New Signage Request

RE: Traffic Signage – Common Street at Spring Street

Project: Reconstruction of Common Street, Watertown, MA Project No: 15-001.02

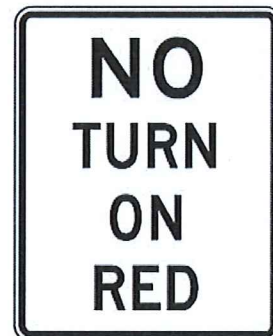
There is a bike box on the Common Street southbound approach to the Common Street/ Spring Street intersection. In accordance with the FHWA Interim Approval for Optional Use of an Intersection Bicycle Box (IA-18), a No Turn on Red Sign is required.

Turns on red shall be prohibited from the approach where a bicycle box is placed using a NO TURN ON RED (R10-11 series) sign.

The recommended "No Turn on Red" sign is a R10-11a sign. The size should be 24" x 30". The sign can be mounted either on the signal post on the southwest corner of the intersection, or on a separate sign post on this same corner.

A photo is shown on the next page identifying the potential location for the sign.
